## CALIFORNIA COASTAL COMMISSION

## REVISED CONDITIONS AND FINDINGS

Application No.: 6-02-119

Applicant: Beach House Restaurant

EXHIBIT NO. 4  
APPLICATION NO.  
6-02-119  
Accessways

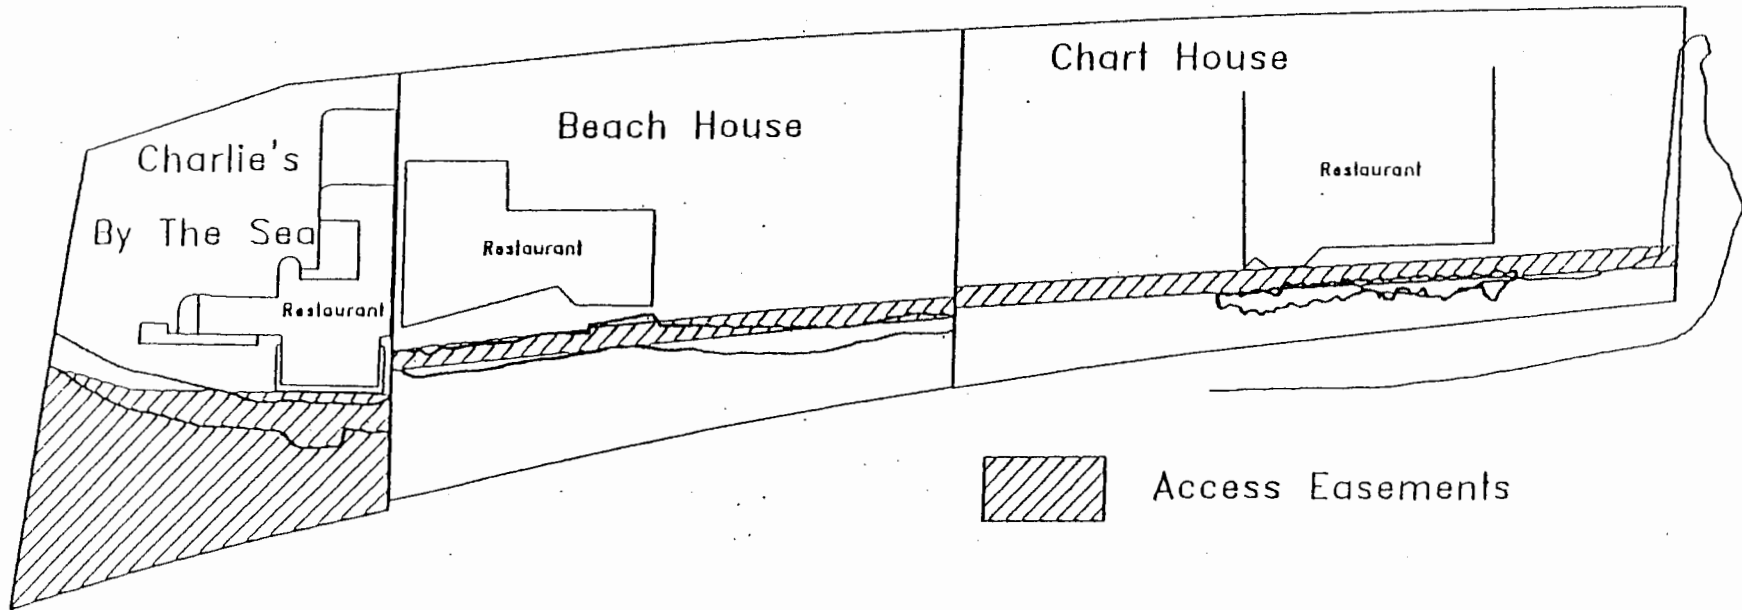
The Commission, through past permit actions, required public access easements on all three of the restaurant row properties (ref. CDPs #6-83-165/Saxten, #F2857/Triton, #6-85-4/Chart House). These were to be located on the dry upland area between the existing restaurants and the revetments located seaward of the restaurants, in order to provide dry access during all tidal regimes and storm conditions. ( The accessways, however, were required at different times and, thus, do not quite form a contiguous path). Exhibit #6 identifies the locations of the public access easements fronting these three restaurants.

The subject property is currently developed with a two-story restaurant, a paved parking lot, landscaped areas and a riprap revetment. The original Commission action on the subject site approved construction of the restaurant in a location that would allow an 8 ft.-wide public accessway to be provided between the restaurant and the revetment. However, although the restaurant appears to be sited in its approved location, the current plans and on-site conditions show that the existing riprap revetment, proposed herein for after-the-fact maintenance and augmentation, and a portion of the dining patio, which is also proposed for after-the-fact approval, are located within the dedicated public

accessway, thereby precluding improvement of the walkway and the potential for the public to use the area. (see Exhibit #5).

**B. PRIOR TO ISSUANCE BY THE EXECUTIVE DIRECTOR OF THE NOI FOR THIS PERMIT**, the applicant shall submit for the review and approval of the Executive Director, and upon such approval, for attachment as an Exhibit to the NOI, a formal legal description and graphic depiction of the portion of the subject property affected by this condition, as generally described above and shown on Exhibit #4 attached to this staff report.

### REVETMENT SECTION (TYPICAL)

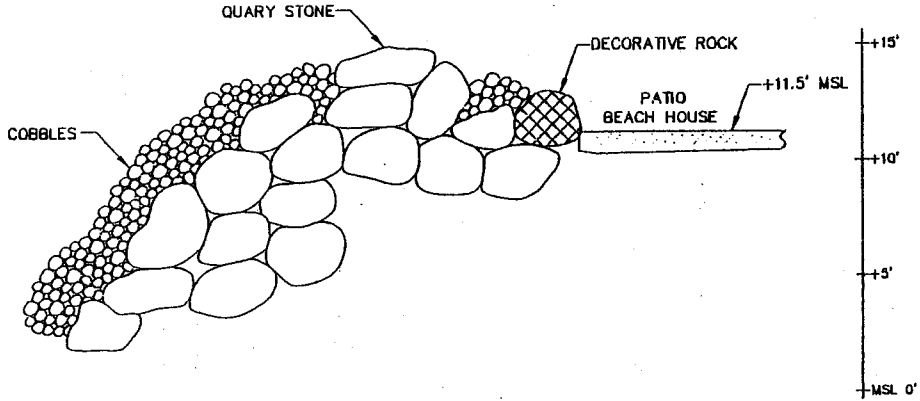
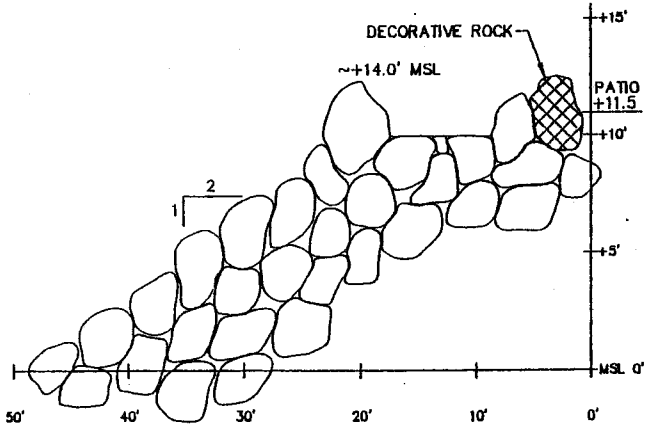
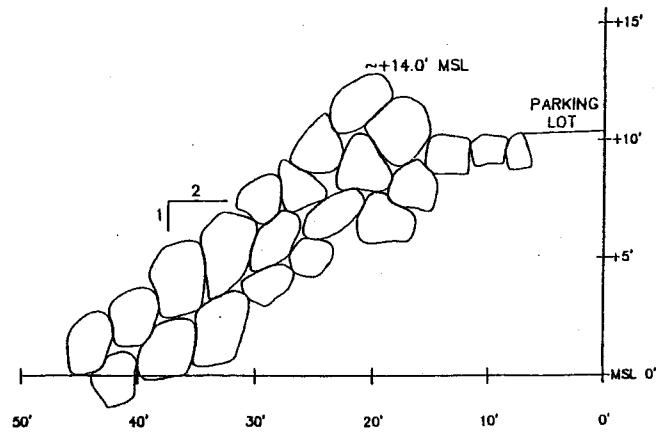
The Commission's engineer has reviewed the proposed walkway design and has identified safety and visual concerns with the proposed elevation of the walkway. As proposed, the walkway is approximately 1 ½ ft. lower than the neighboring restaurant patio with, in some places, a large approximately 4 ft.-high rip rap stone on its seaward side. The safety concern is that the large stone may become dislodged onto the path and the visual concern is that small children may not be able to see over the stone. Special

Condition #1d requires the applicant to revise the project to increase the height of the walkway to at least the same elevation of the neighboring patio which is approximately 11.5 ft. above Mean Sea Level (MSL). By elevating the path, the revetment will be more stable, safe and usable. Additionally, public views toward the ocean from the pathway must be maintained.

- a. The proposed revetment has been engineered such that the encroachment onto the beach is the minimum necessary to protect the structure, and that all riprap that has migrated beyond the toe of the revetment has been removed or incorporated into the revetment. In no case shall the repaired revetment encroach further seaward than the existing revetment, as shown on Exhibit #4.
- b. The access path shall be permeable so as to permit runoff to filter through the path.
- c. The access path shall contain a level surface so as to facilitate public access.
- d. The elevation of the access path shall be revised to be at or above the grade of the adjacent outdoor dining patio (approximately 11.5 ft. above Mean Sea Level (MSL)) so as to maximize views of the ocean by users of the path.
